# ADDENDUM

Date Issued:	July 28, 2025
Project:	Intermountain Health Alta View Hospital – IR Rad Room #2 Remodel 9660 South 1300 East Sandy, Utah 84094
Addendum Number:	1

## IR Rad Room #2 Remodel

NJRA Project # 24239.00  
Construction Documents June 4, 2025  
I Addendum I July 28, 2025

A251

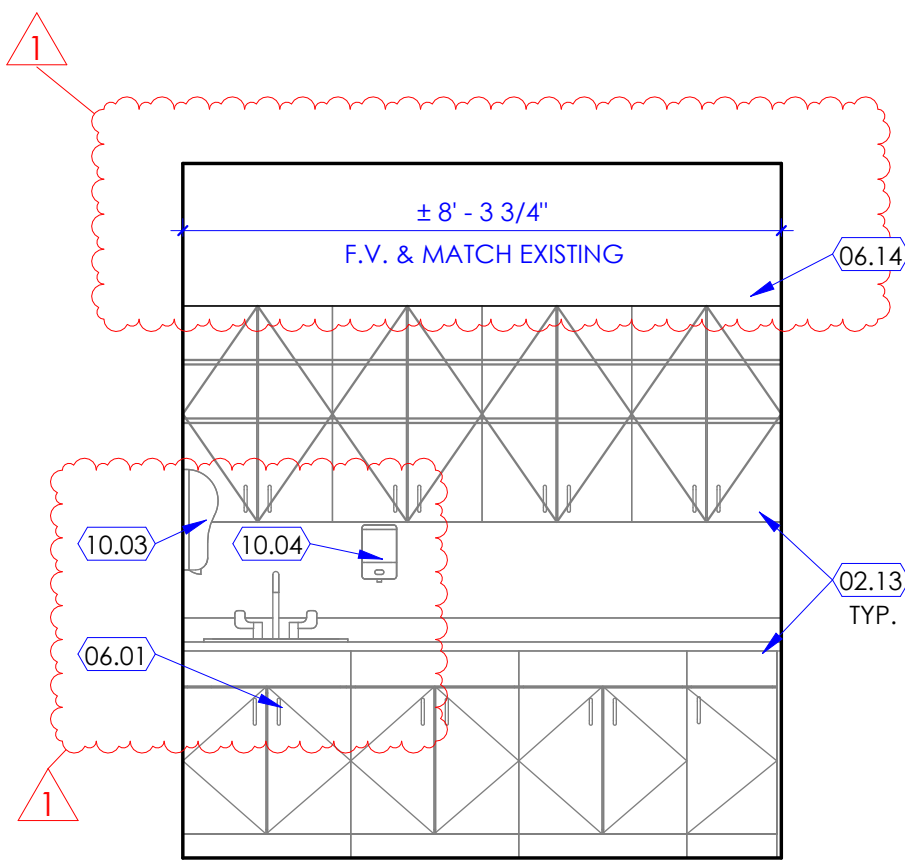
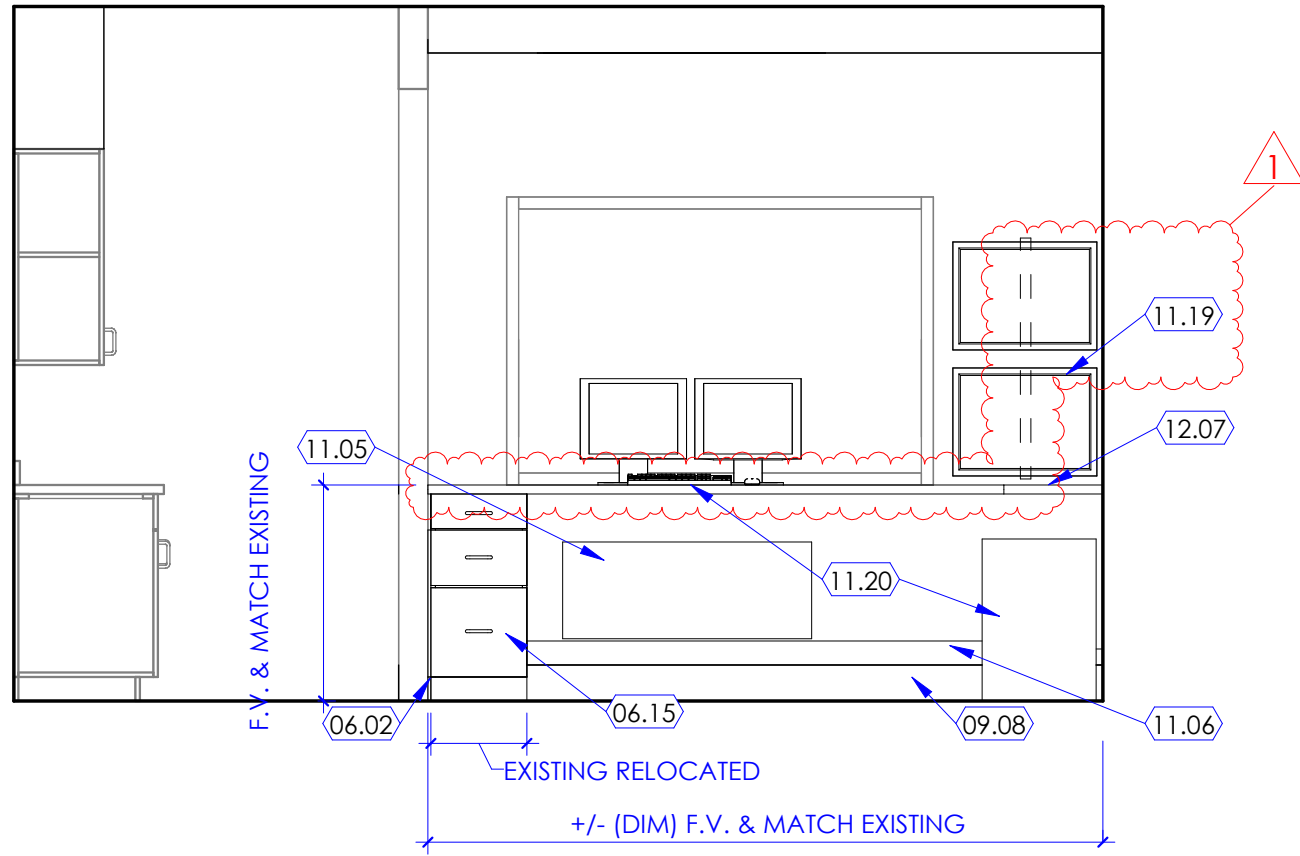
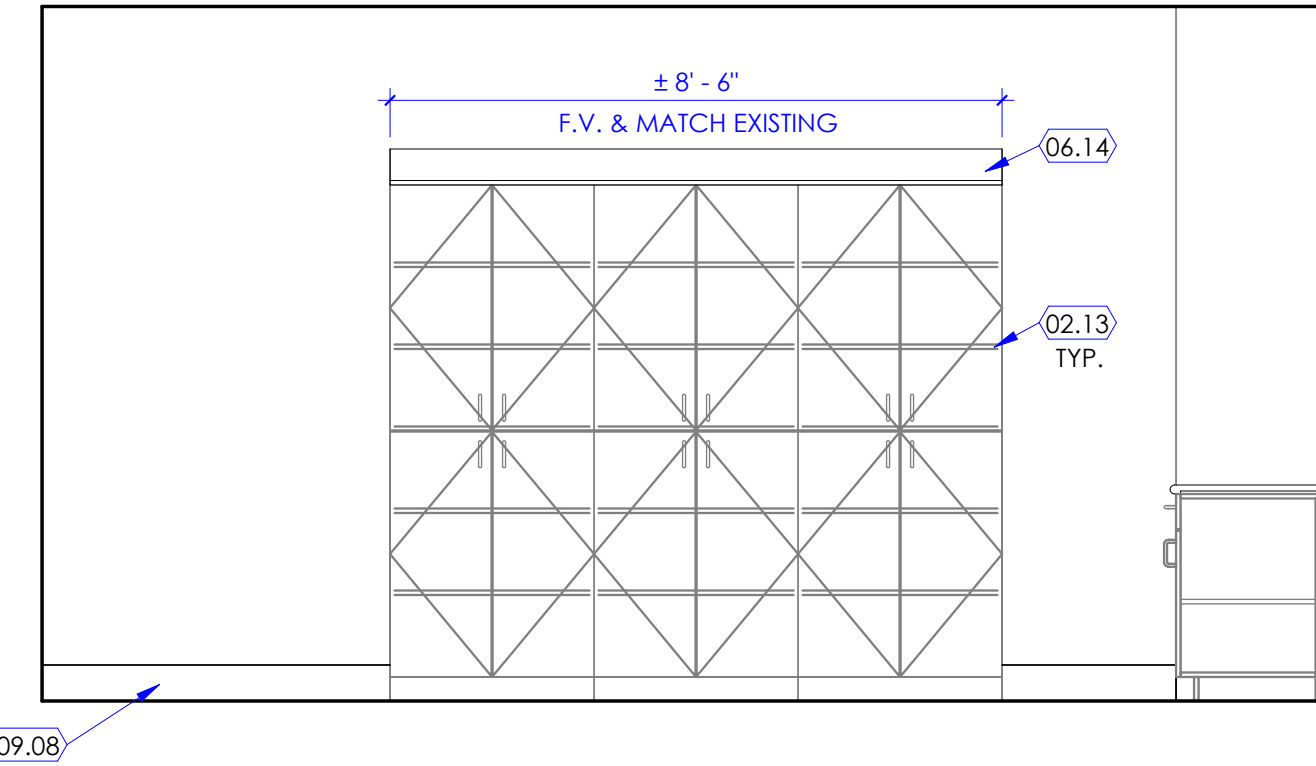
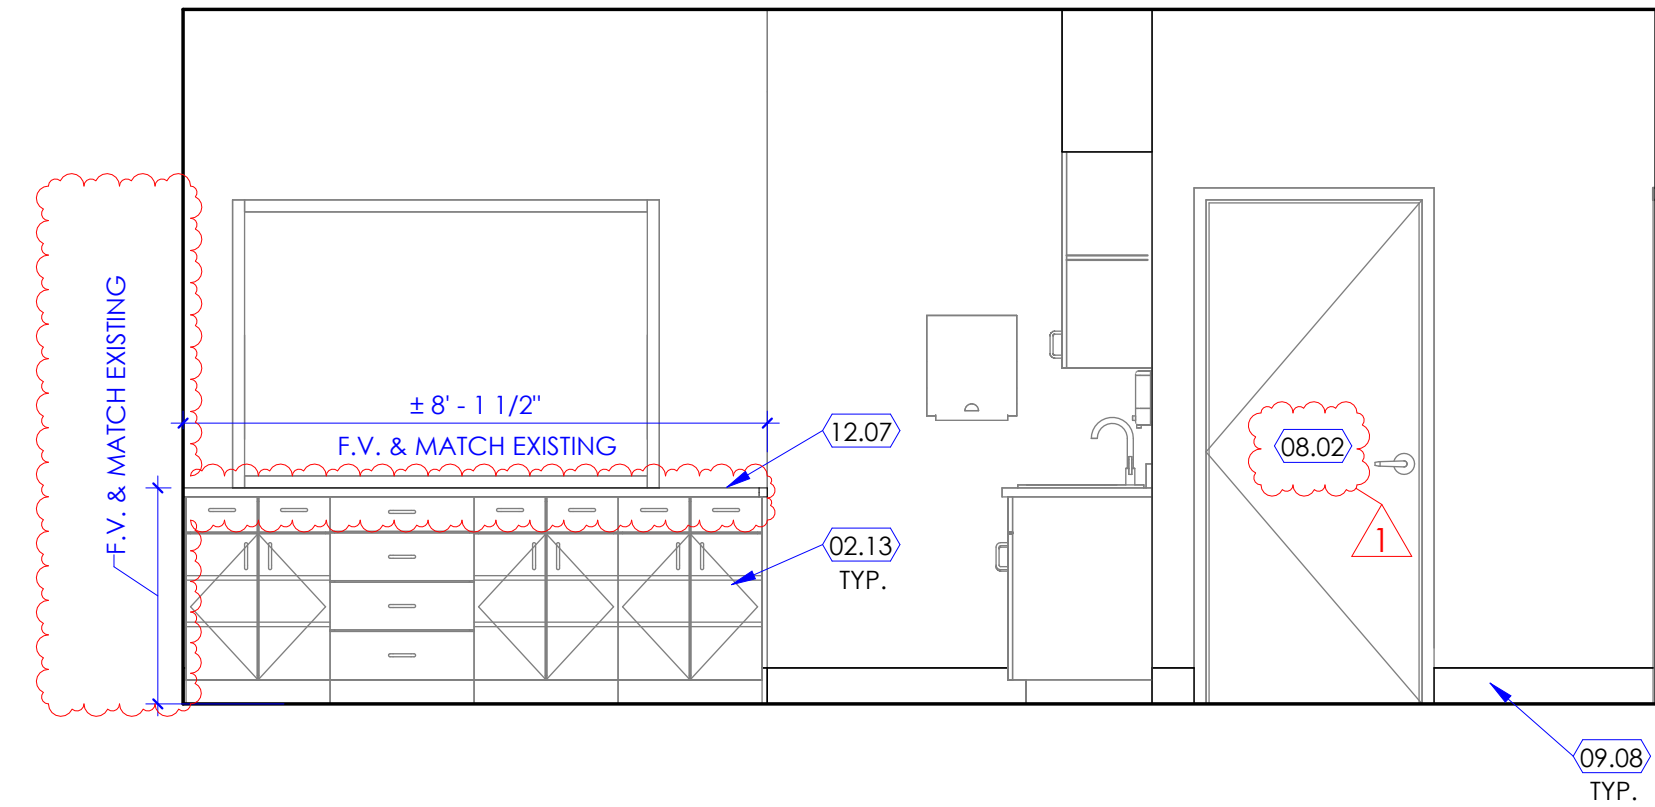
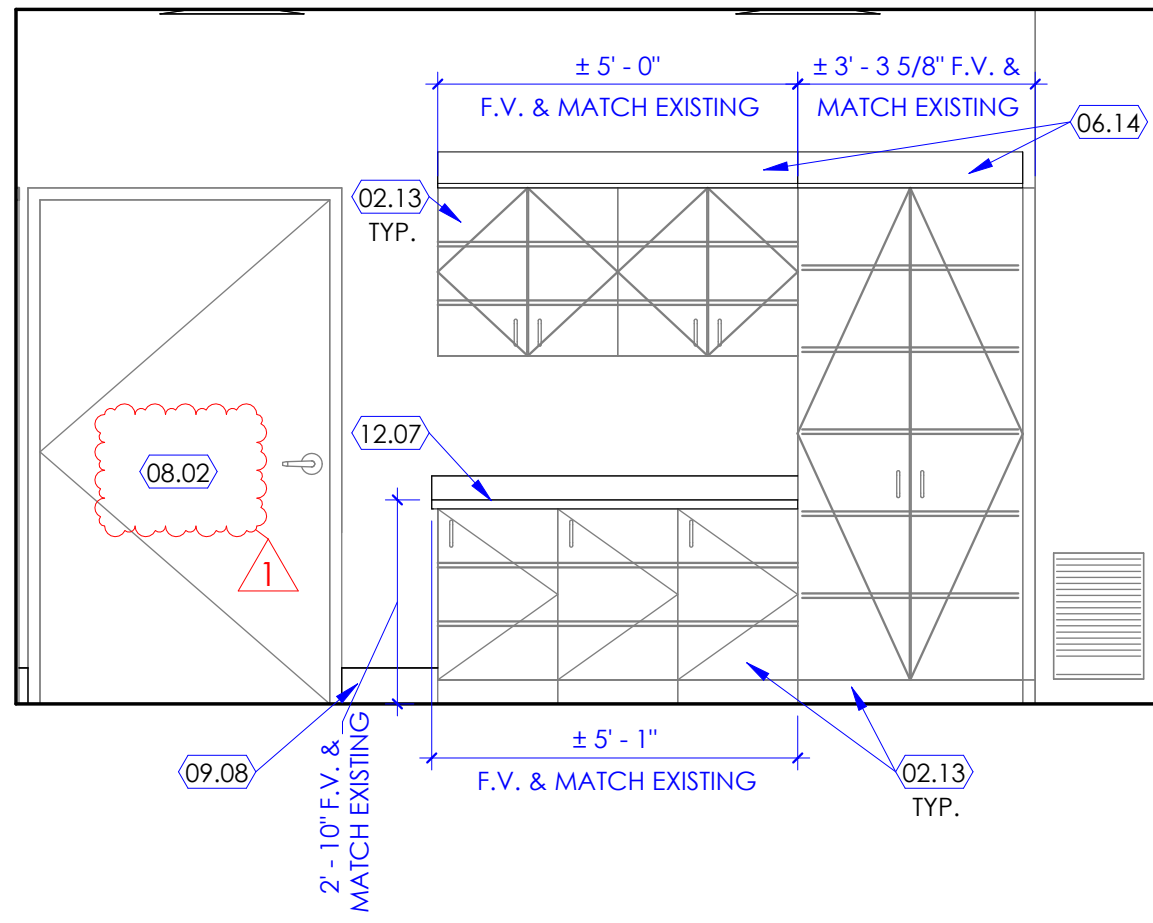
Sheet Number	Drawings
	Revise fascia above existing cabinets in one location to be vertical instead of sloped top.
A122	Revise keynote 02.16 to clarify existing grids to remain. Add keynote 06. for vertical fascia above cabinets. Revise keynote 09.06 to give a basis of design for new ceiling tiles. Add keynote 23.01 to clarify mechanical diffusers to be coordinated in ceiling. Add keynote 26.03 to clarify electrical lighting in ceiling. Indicate ceiling heights are to match existing.
A251	Detail 1/A251, Revise fascia in to be a vertical fascia to ceiling and change keynote to 06.13. Add keynote 06.01, 10.03, and 10.04 to maintain health department requirements for locking cabinet beneath sink, paper towel dispenser and soap dispenser in sink proximity. Detail 2/A251, Revise countertop height to reflect existing conditions that do not allow for a backsplash and revise keynote 11.19 for monitor wall bracket coordination with facility. Detail 4/A251 Revise countertop height to reflect existing conditions that do not allow for a backsplash and add keynote 08.02 to identify lead shielded door to be protected. Detail 5/A251 Add keynote 08.02 to identify lead shielded door to be protected.
